Staff Summary Report

Development Review Commission Date: 09/28/10

SUBJECT: Hold a public meeting for a Development Plan Review for **CITY OF TEMPE SOUTH WATER TREATMENT PLANT ENVIRONMENTAL LABORATORY** located at 6600 South Price Road.

DPR10149 – Development Plan Review including site plan, building elevations, and landscape plan.

OVERALL FLOOR PLAN

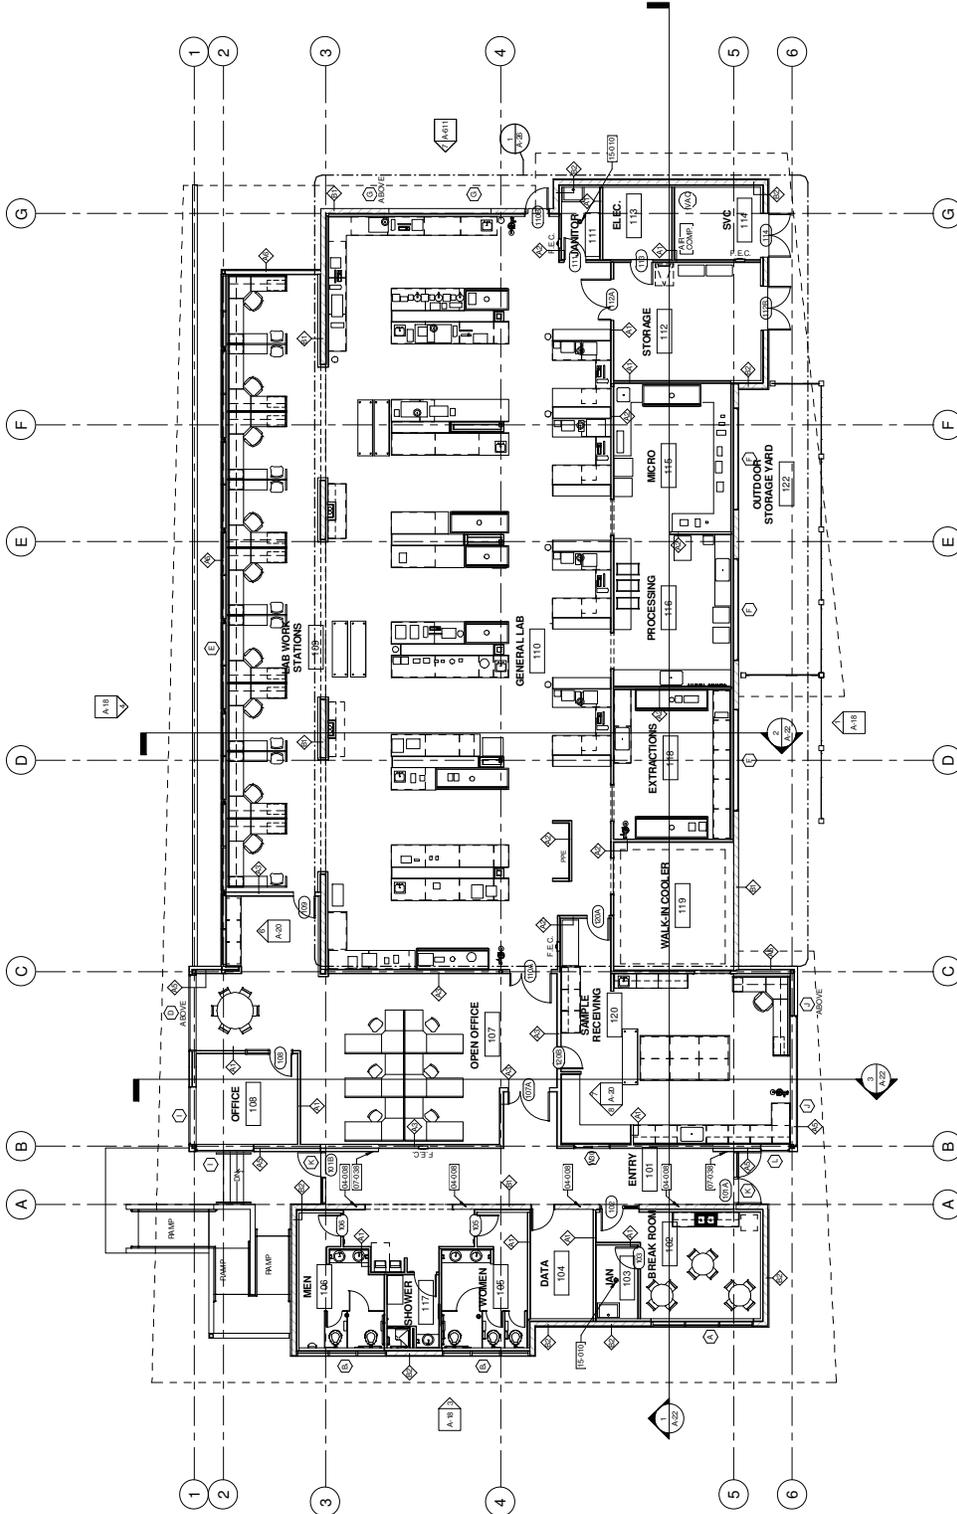
5. The Service Room # 114 double doors, as is indicated, are not required to have vision panels.
6. Restroom and shower room security:
 - a. Lights in restrooms:
 - 1) Provide 50% night lights
 - 2) Activate by automatic sensors, key or remote control mechanism
 - b. Single user shower room door hardware: Provide a key bypass on the exterior side of the door.
